SERVICE No. 546 BULLETIN

Piper Aircraft Corporation

"Modification DOA EA-1 Approved"

Inspection of Whelen Wing Tip Strobe Lights;
Reference F.A.A. Airworthiness Directive
75-05-04

WHELEN NAVIGATION AND STROBE LIGHT ASSEMBLY

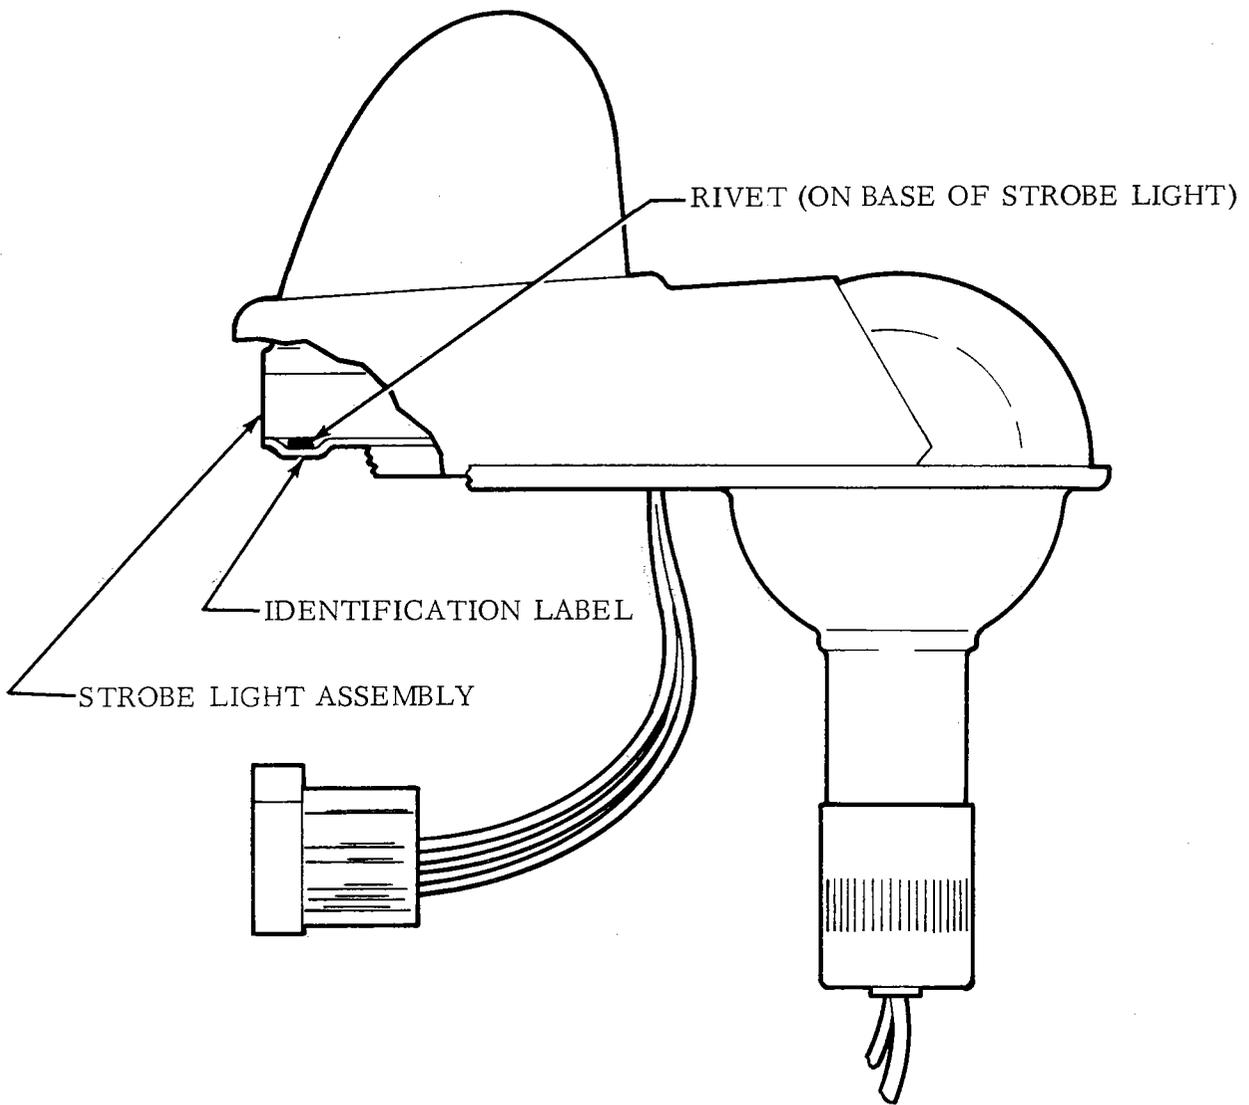
1. Expose wing tip strobe light assembly to view (refer to attached sketch for a typical strobe light assembly illustrated view).
2. If the following modification has already been accomplished, no further action is required; make appropriate entry in aircraft log book re compliance with this Service Release.

3. If the following modification has not been accomplished, proceed as follows:
 - a. Install on the base of the Whelen A-427 Flash Tube Assembly a pressure sensitive vinyl label conforming to Whelen drawing no. A-30052, Revision 1 dated October 15, 1974 or later F.A.A. approved revision.

1. Scotch Brand Type 33+ Vinyl Plastic electrical tape or equivalent tape - approved by an F.A.A. Maintenance/Avionics Inspector may be used in lieu of the vinyl label (if any plastic tape is used, it must be formed to cover the rivet at the rear of the flash tube without covering the identifying part number).

3. b. If the flash tube incorporates a label, the new label or tape may be installed directly over the old label.
- c. Install label or tape only when the label or tape and the flash tube are at a temperature above 50 degrees F.
4. Make appropriate service release compliance entry in aircraft log book.
